TO: ALL VOLVO RETAILERS
RE: RECALL 180

VOLVO				TITLE:		GROUP:	NO:	
				Recall 180: Adjust Driver's Door Bowden Cable		83	180	
Service Manager Bulletin				2007 C70		ISSUING DEPARTMENT:		
						Warranty		
				REFERENCE BULLETINS:		CARMARKET:		
				TNN# 83-180		United States, Canada		
Service Personnel: read and initial.	SERVICE MANAGER	SERVICE WRITER	WARRANTY ADMINISTRATOR	DATE:		YEAR	MONTH	DAY
				2007 06 14				
				Page 1 of 3

SUBJECT: Recall 180: C70 Bowden Cable Attachment
REFERENCE: VIDA, Service Manager Bulletin 83-180

Drip protection sheet removal

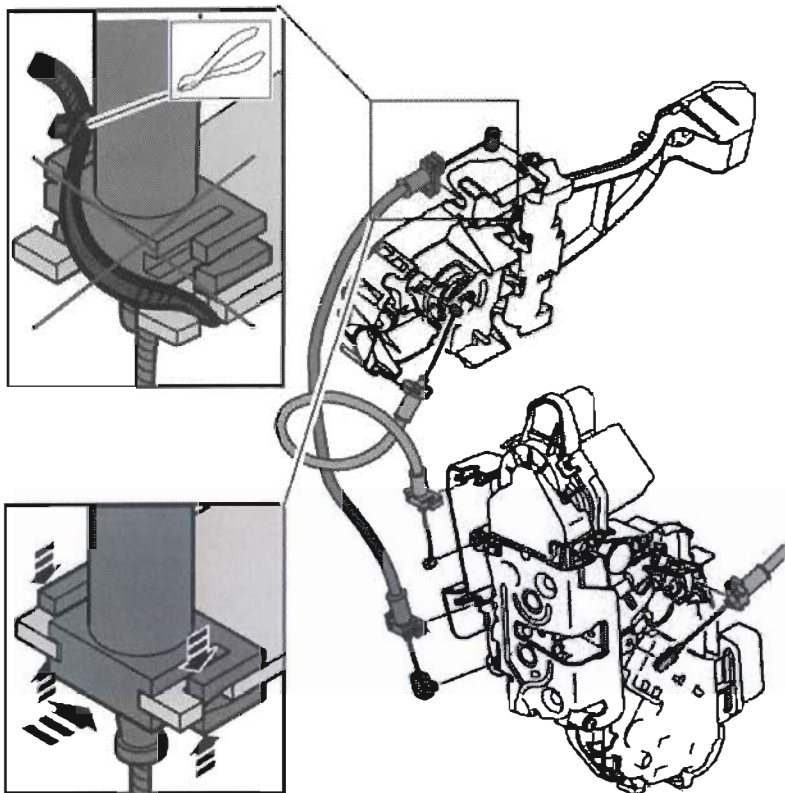
Start to remove the drip protection sheet at the top with a bone tool, P/N 9814071, see photo. Cut the glue with the bone tool.

Cut the glue from A to B as shown and open the drip protection sheet, so you can reach the outer door handle bracket and the latch.

Any remaining glue on the door must be removed.
